RE: 833 Dolores Dr. NW
Grading and Drainage Plan
Engineer's Stamp Date: 12/24/19
Hydrology File: J11D040

DRAINAGE AND TRANSPORTATION INFORMATION SHEET (REV 6/2018)

RE: 833 Dolores Dr. NW
Grading and Drainage Plan
Engineer's Stamp Date: 12/13/19
Hydrology File: J11D040

ENGINEER'S SEAL	833 DOLORES DR. GRADING AND DRAINAGE PLAN	DRAWN BY DEM
DAVID SOULE P.E. #14522		DATE 12-12-19
	 1608 CENTRAL AVENUE SE SUITE 201 ALBUQUERQUE, NM 87106 (505) 972-0899	833 DOLORES.DWG
		SHEET # C1
		JOB #

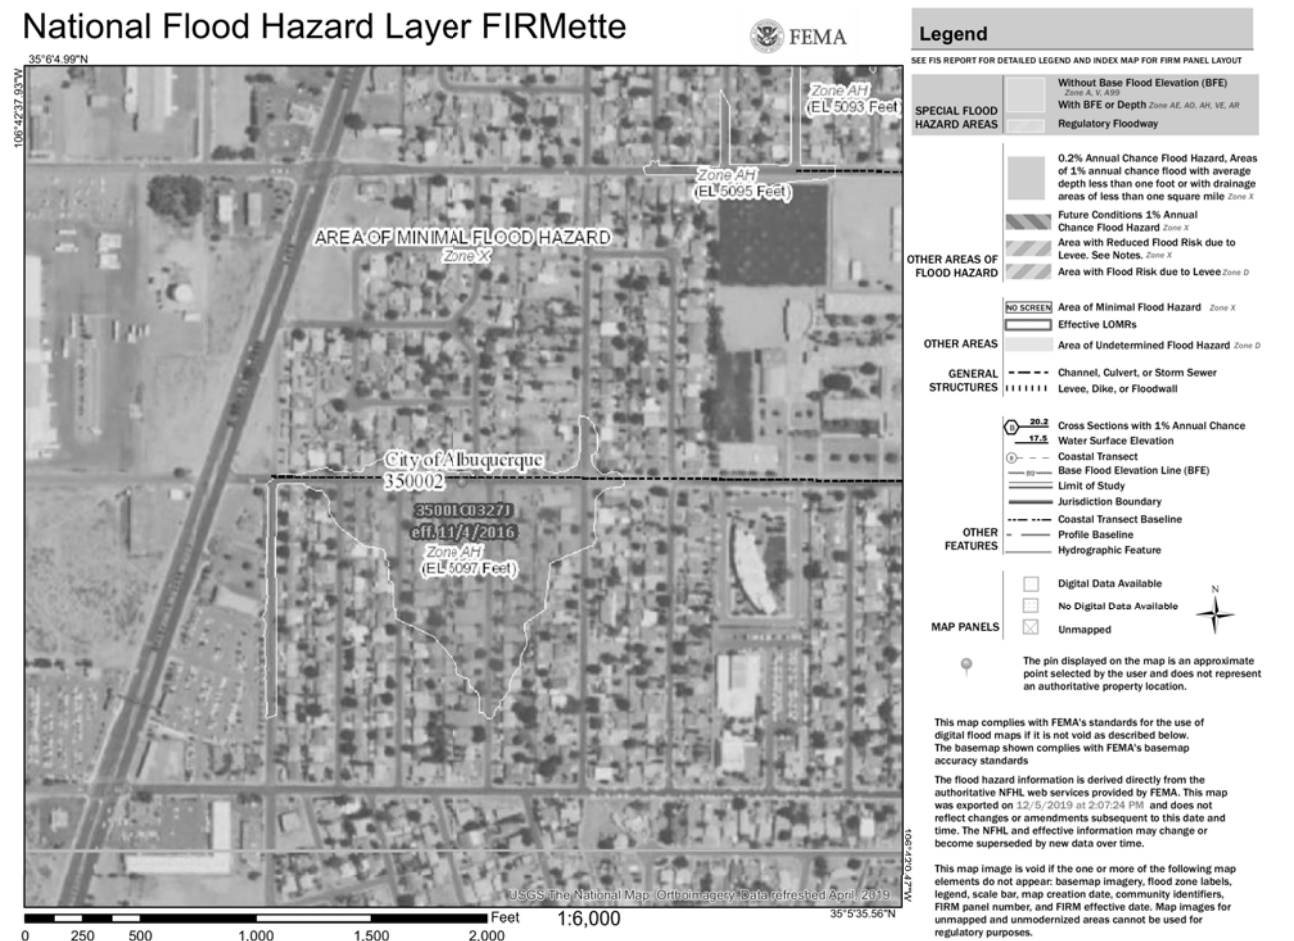
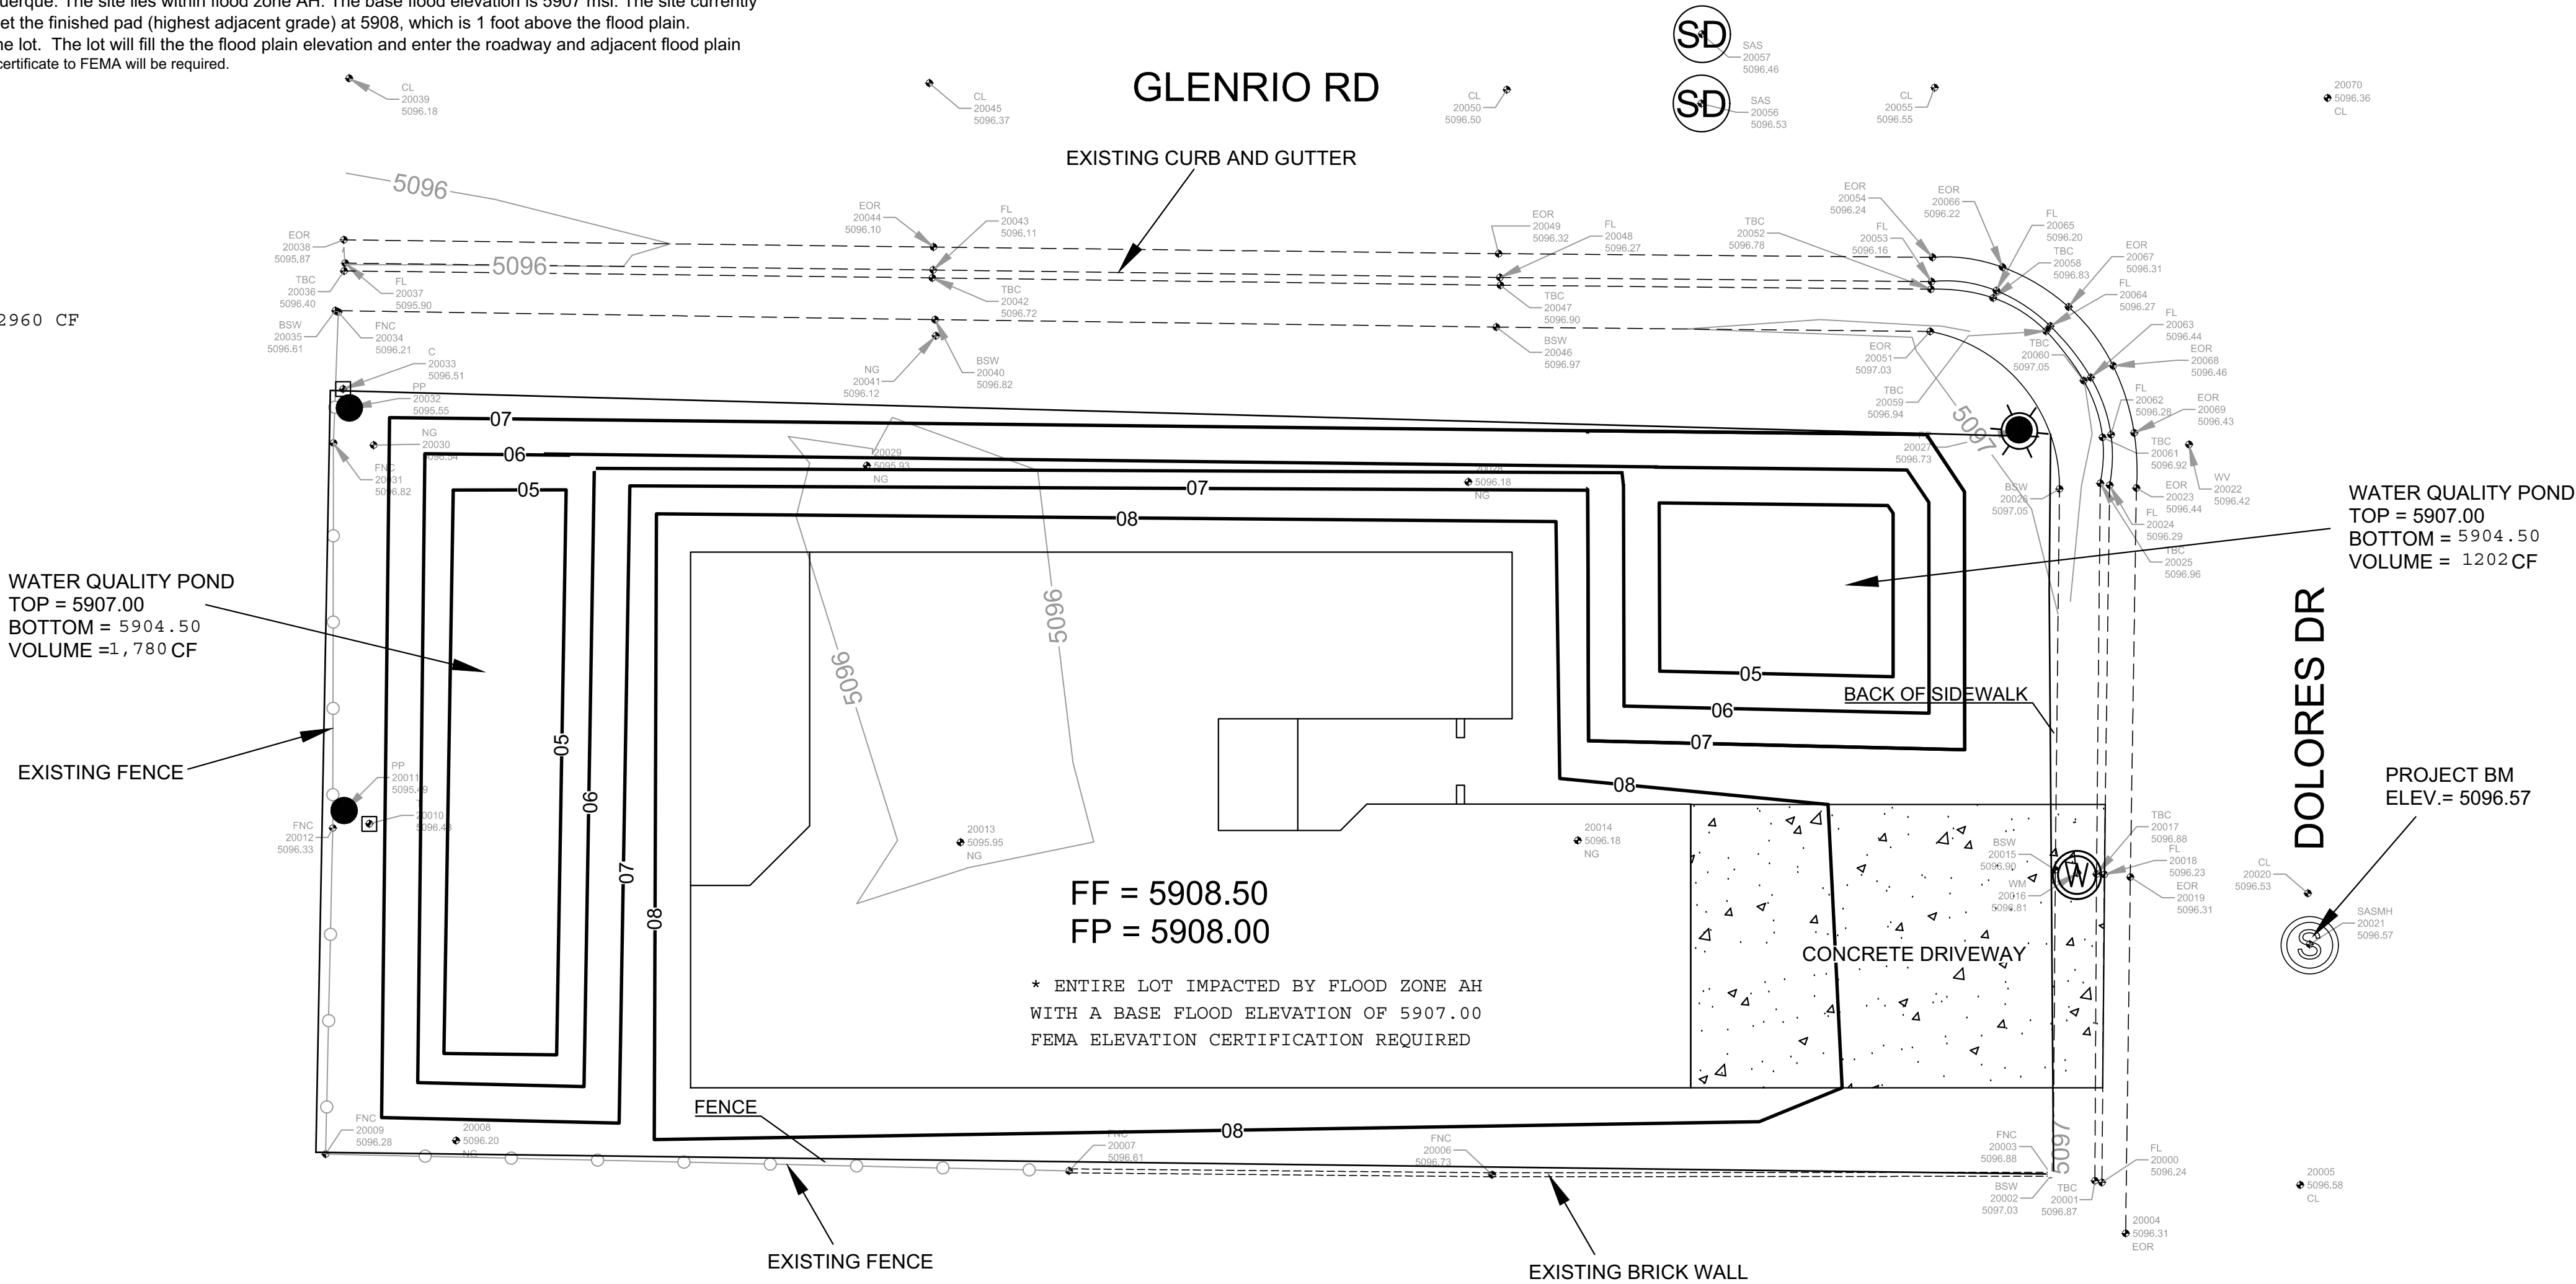
Based upon the information provided in your submittal received 12/13/2019, the Grading and Drainage Plan **is not** approved for Building Permit. The following comments need to be addressed for approval of the above referenced project:

1. As stated on the plans, this site is located in a floodplain (AH – Elev 5907) and must have a floodplain development permit prior to issuing the Building Permit. The permit application must demonstrate zero rise to the base flood elevation, unless a Letter of Map Revision (LOMR) is being prepared. Please contact Rudy Rael, CFM for more information regarding floodplain development permits (rrael@cabq.gov or 924-3977).
2. Since this needs only needs a floodplain development permit, an administration fee of \$40 will be required at the time of resubmittal.

Based upon the information provided in your resubmittal received 12/24/19, the Grading and Drainage Plan is approved for Building Permit.

Once the grading is complete, a pad certification will be required prior to release of Building Permit. Please attach a copy of this approved plan in the construction sets for Building Permit processing along with a copy of this letter and the pad certification approval letter.

Prior to approval in support of Permanent Release of Occupancy by Hydrology, Engineer Certification per the DPM checklist will be required. Also a formal Elevation Certificate needs to be submitted to Hydrology.
